Christine Lintott  
Architects

**Re: Development Permit Application Resubmission  
515 Chatham Street**

## Response to Comments

CHATHAM STREET ELEVATION - CURRENT PROPOSAL

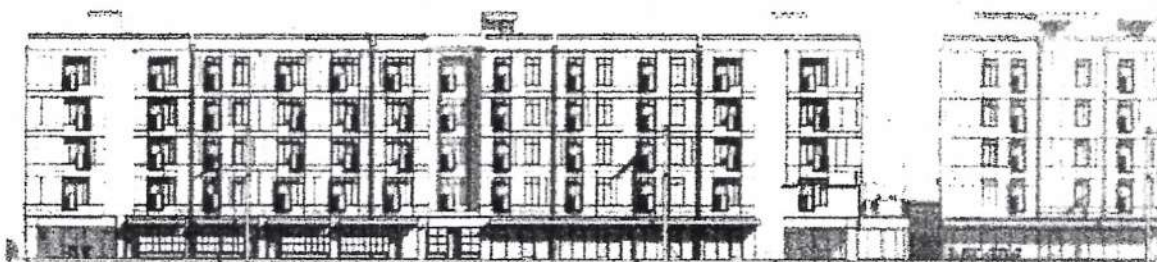
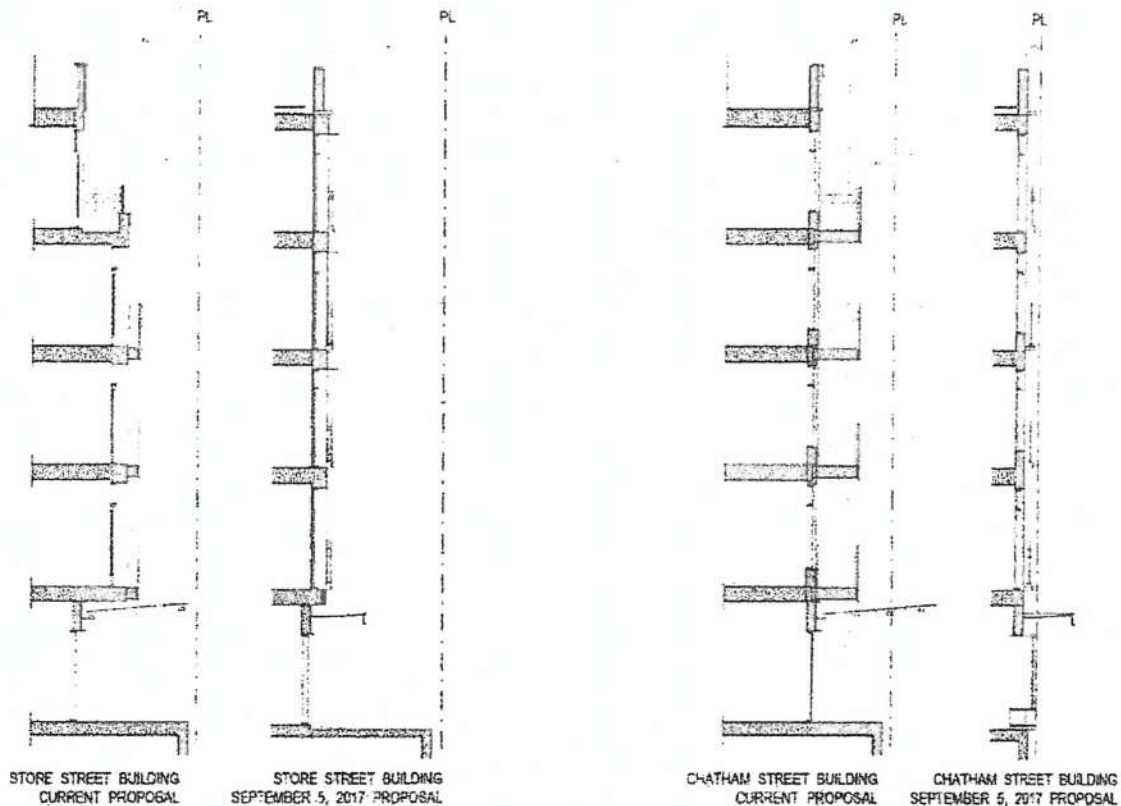
**RECOMMENDATION:** That the perceived scale and massing of the building be reduced to better fit with the fine grain and small lot character of the Old Town district.

- Reduction in overall scope of the project. The proposed site now comprises three consolidated lots instead of the originally proposed five. This reduces the developed frontage along Chatham street from an originally proposed 105m to the currently proposed 63m

- Increase in size and scale of articulation in the project façade. The main plane of the building has been pulled further back from the property line (1.595m at Chatham Street and 0.945m at Store Street) and substantial bays added to effectively break up the perceived mass. The articulation is further reinforced by the introduction of full walk out balconies.

CHATHAM STREET LEVEL PLAN - CURRENT PROPOSAL

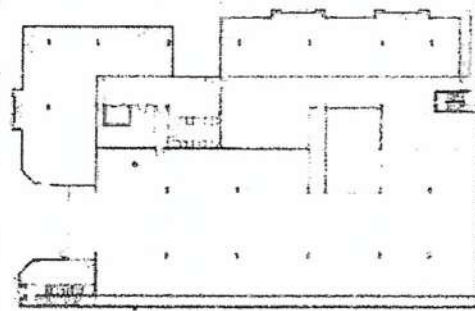
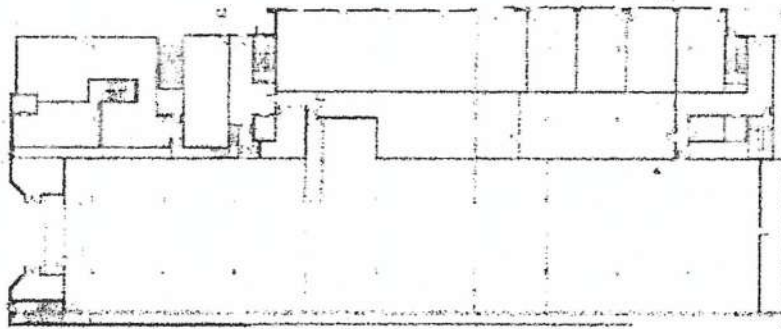
**RECOMMENDATION:** That additional opportunities be created for “lingering” in the public realm along Store and Chatham Streets

- Increased building articulation at street level. A sequence of covered recesses and eddies have been developed along the building edge at street level that encourage a range of commercial and pedestrian activities on the site.
- Increased shelter in public realm. The commercial level canopy has been substantially increased in depth and provides meaningful weather protection along both the Store Street and Chatham Street elevations.
